Supplemental Design Revisions for 2015
Hudson River PCBs Superfund Site

Revised September 2015

Prepared for:
General Electric Company

Prepared by:
ARCADIS of New York, Inc.
6723 Towpath Road
P O Box 66
Syracuse
New York 13214-0066
Tel 315 446 9120
Fax 315 449 0017

FIGURE
1-2a

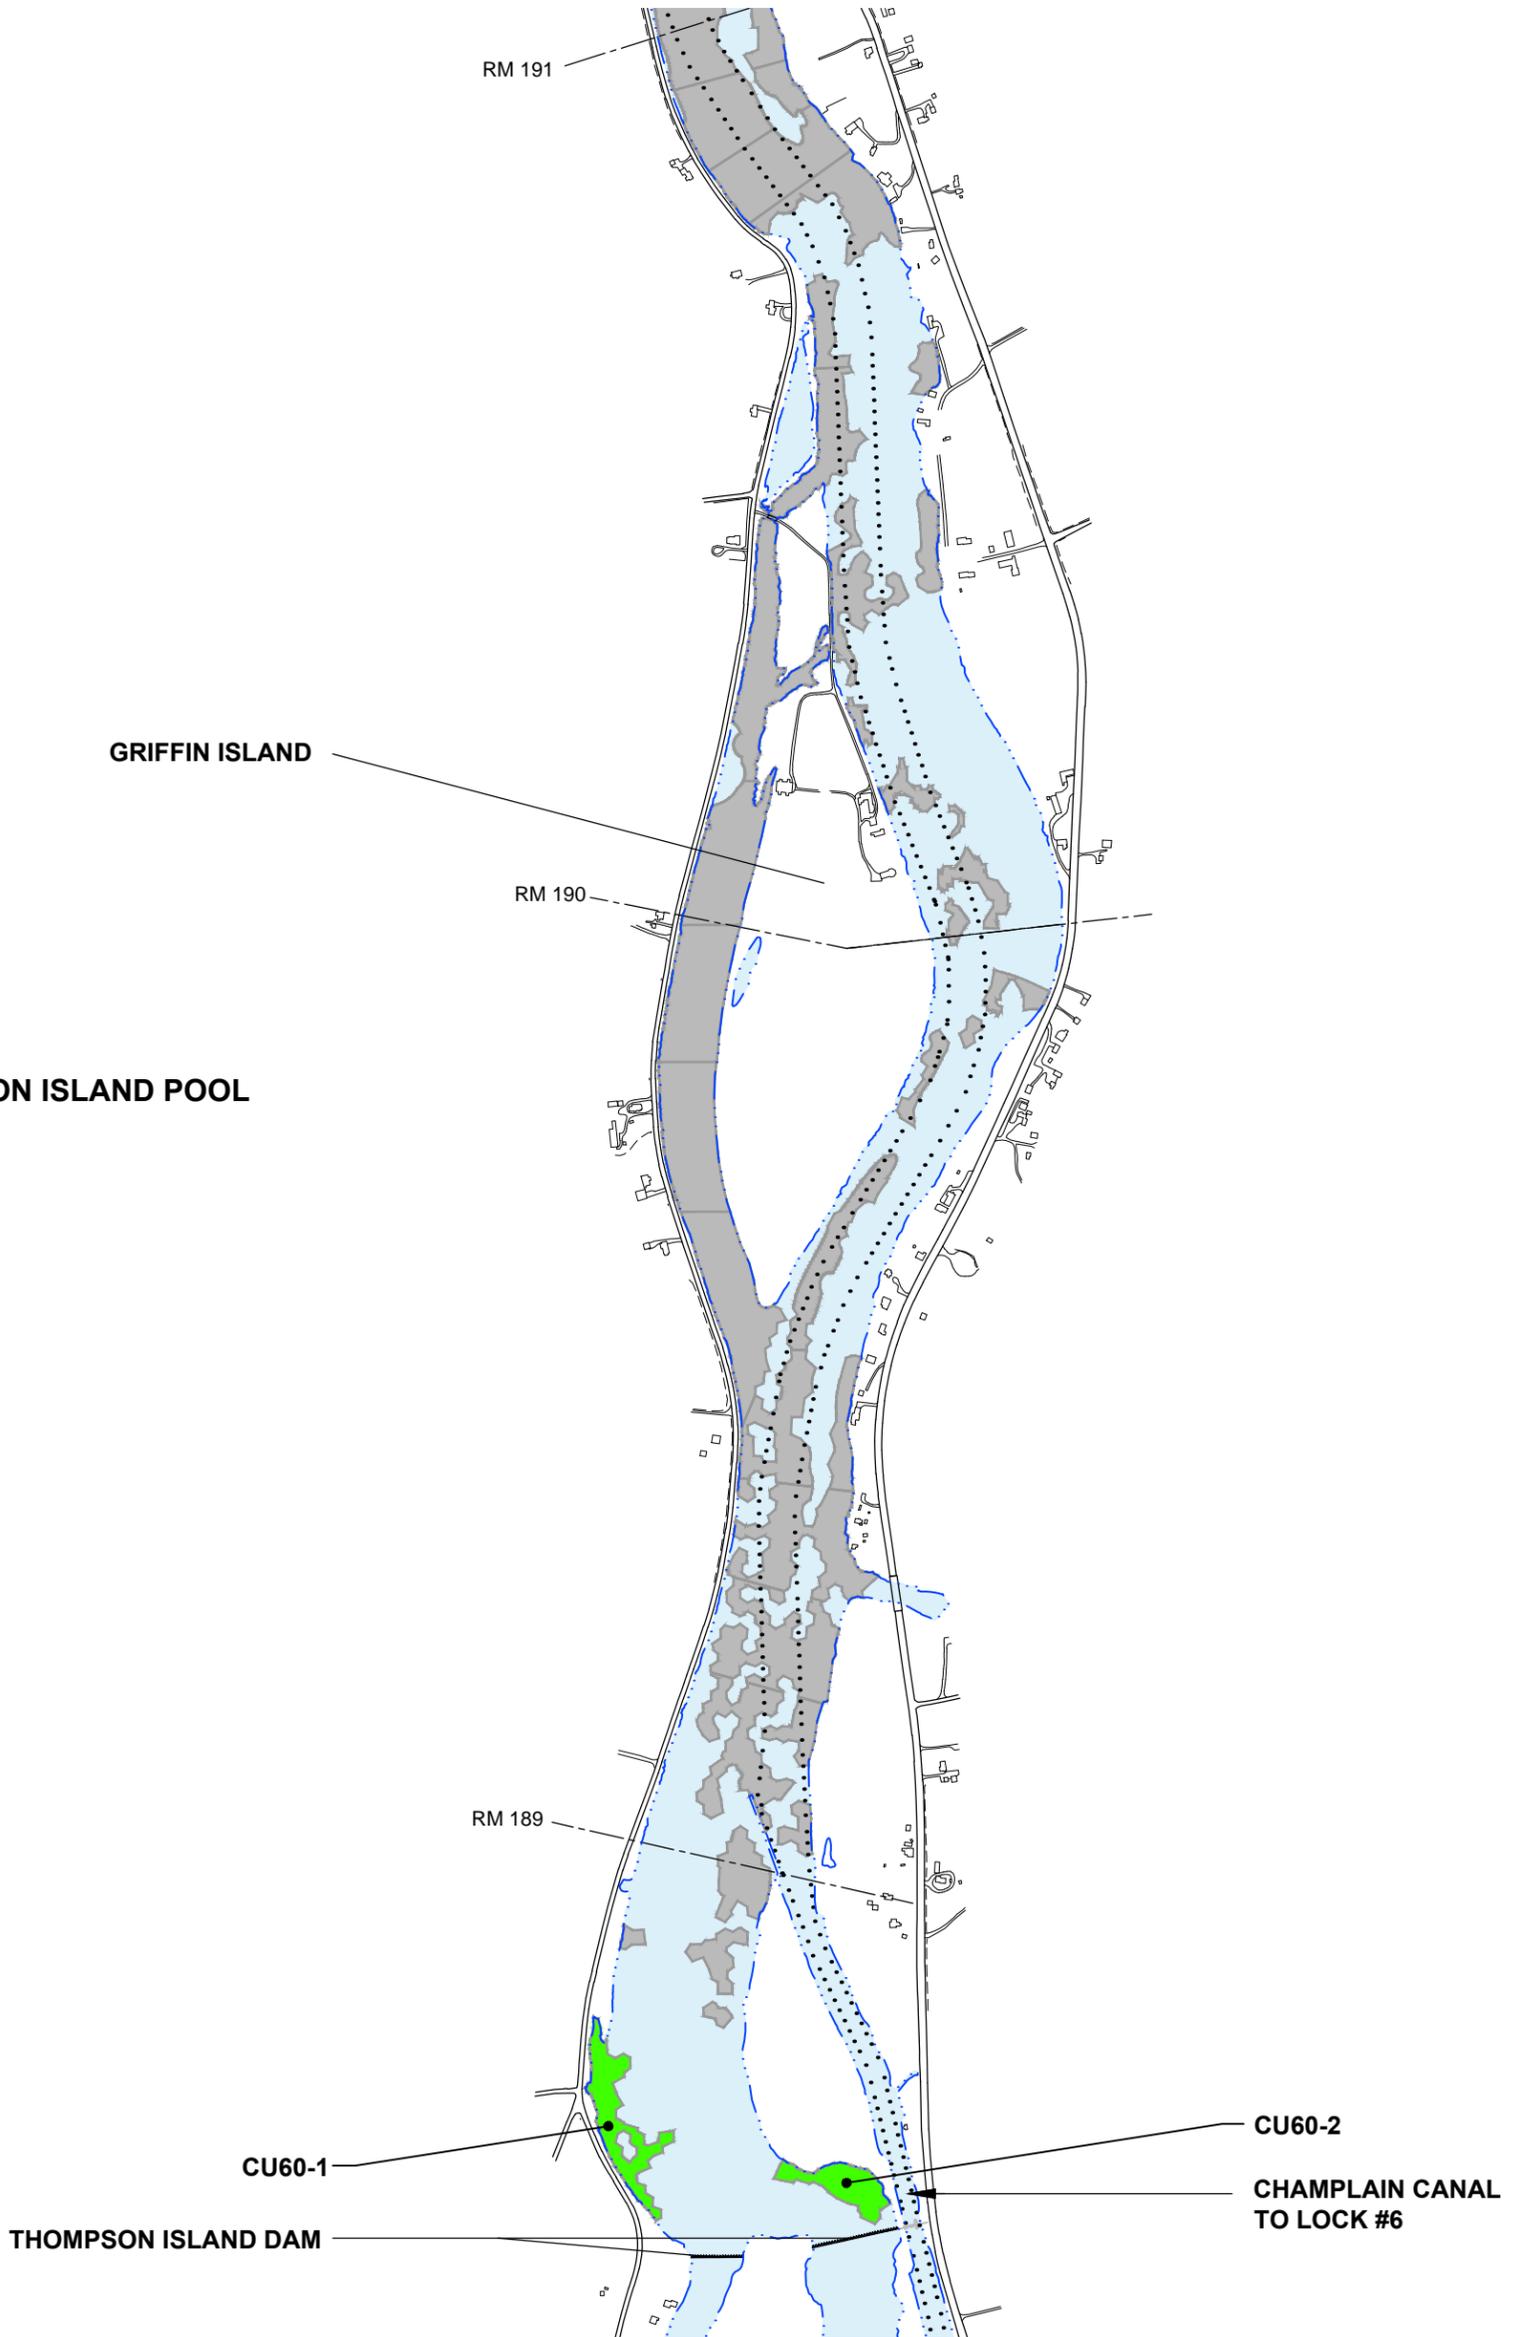
- The remedial design for dredging operations in CU60, which is close to the Thompson Island Dam, was revised based on further evaluation of methods for working safely in close proximity to the dam, as well as discussions with EPA regarding the procedures for dredging in sub-unit CU60-2, which is closest to the dam. Section 2 presents a description of the proposed design revisions for CU60.

Field observations during 2013 in preparation for dredging operations in CU60 indicated that portions of CU60-1 were above the established 119 ft shoreline elevation. Therefore, in August 2013, GE retained Van Dusen & Steves Land Surveyors to conduct a land survey of the 119 ft NAVD88 shoreline elevation along the western shore of the river in the vicinity of CU60-1.

Based on the results of the August 2013 survey, the shoreline boundary and the shoreline extent of CU60-1 were adjusted to correspond with the surveyed location of the 119 ft elevation. Electronic data files with the updated shoreline coordinates and the updated CU boundaries are provided on the CD-ROM included with this document. The updated shoreline and CU boundaries have been incorporated into the revised Contract 42A drawings included in Attachment A.

FIGURE
1-2c

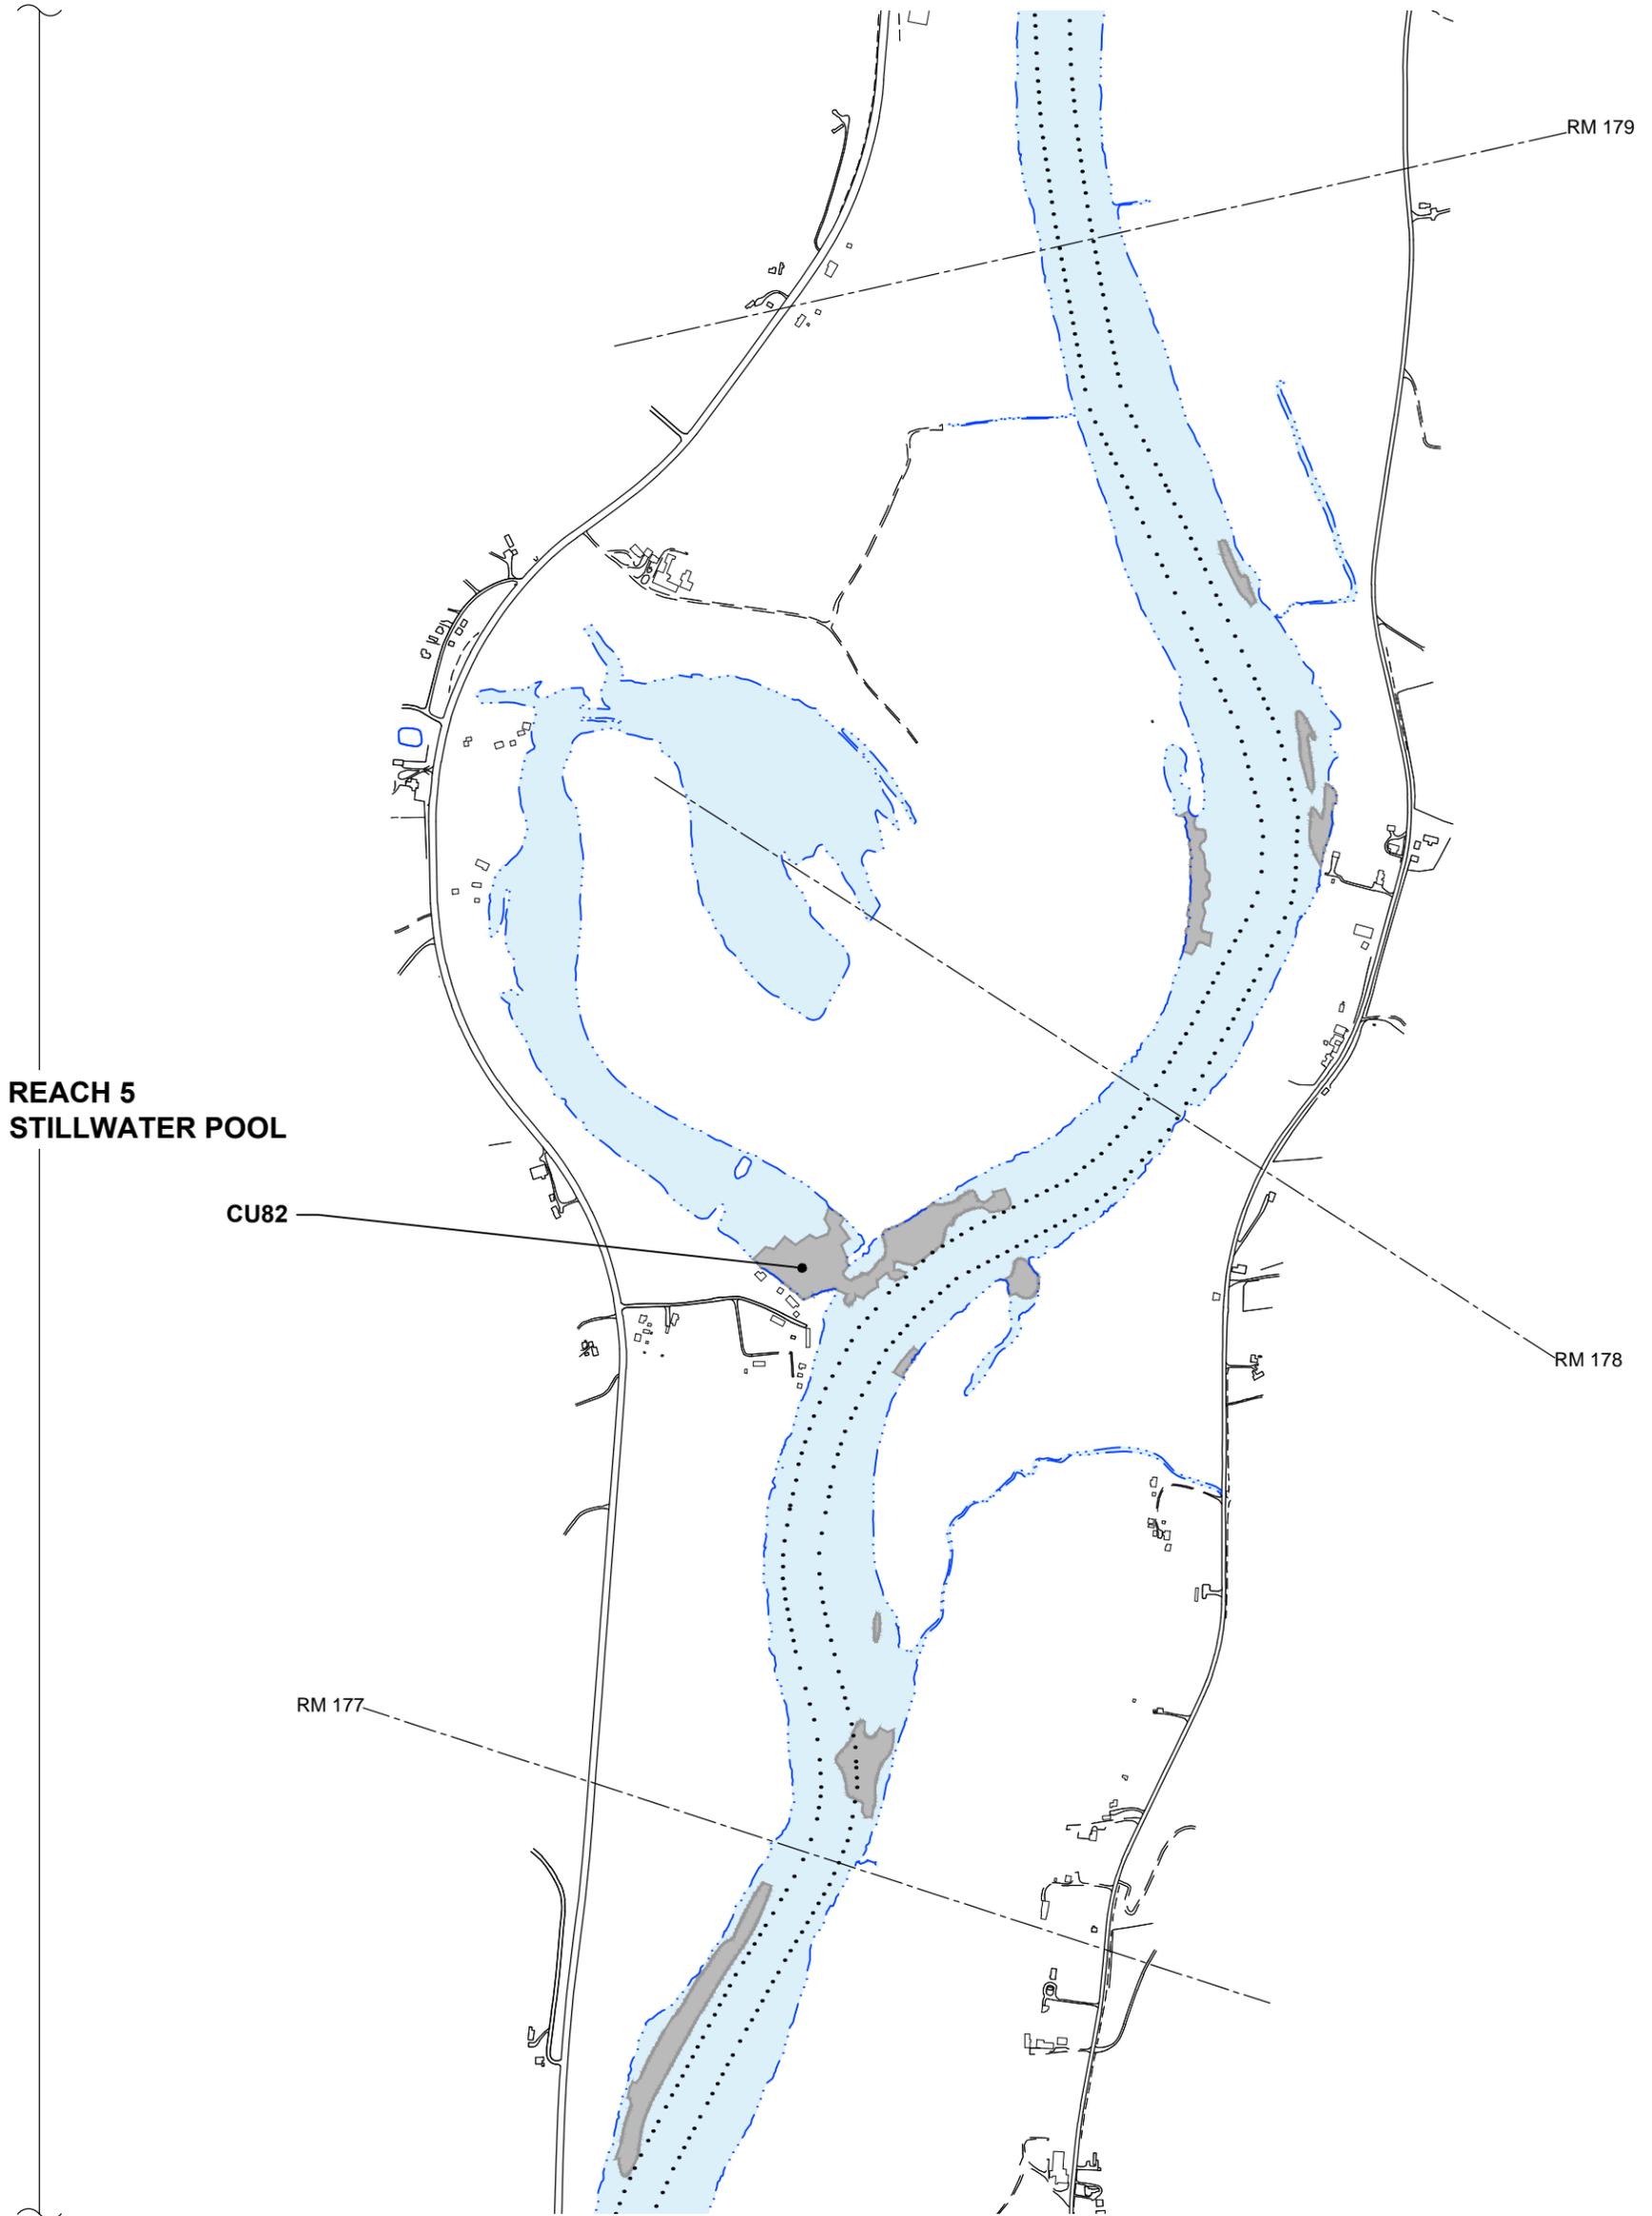
- The conceptual habitat construction design for CU82 in Reach 5 has been updated based on comments provided by and discussions with EPA. Figure 1-2c shows the location of CU82. Section 4 presents a description of the habitat construction design revisions for CU82.
